To:	Gary Collins	From:	Drainage (Cecily Austin)
------------	--------------	--------------	--------------------------

Planning App Ref:	PL/2026/05190
Service Ref:	Drainage
Date:	23/09/2026

Discharge of conditions 11, 22, 23 and 25 of 15/04736/OUT (Tree Protection, Surface Water Discharge, Sewage Disposal Details and External Lighting).

Land south east of Trowbridge

Figure 1: Proposed ditch noted on submitted drainage drawings

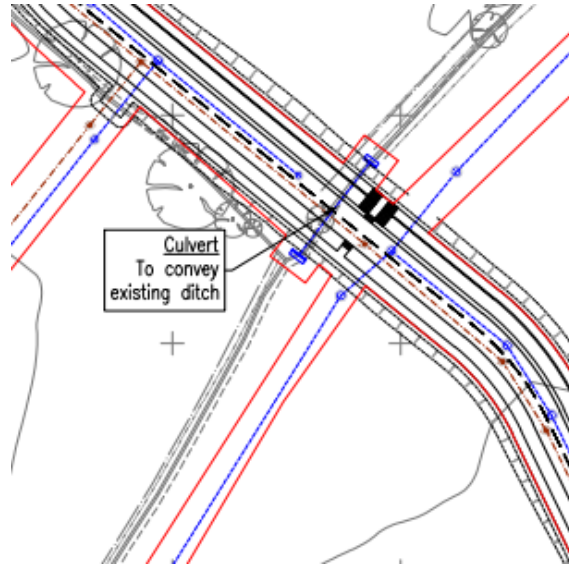
However, a proposed culvert is shown on the submitted drainage drawings (see screenshot below), and no supporting information has been provided regarding its design or operation. Further details are therefore required, including the proposed arrangement, cross-sections, hydraulic capacity and evidence demonstrating that the culvert will not increase or exacerbate flood risk either on or offsite.

- Further details of the proposed culvert, including a description of the works and associated drawings. This should include cross-sections showing the proposed pipework and any associated earthworks required to facilitate the culverting.
- Sufficient supporting information should be provided to demonstrate that the proposed culvert will not increase or exacerbate flood risk on-site or elsewhere, and that it has sufficient capacity to accommodate existing and proposed flows.
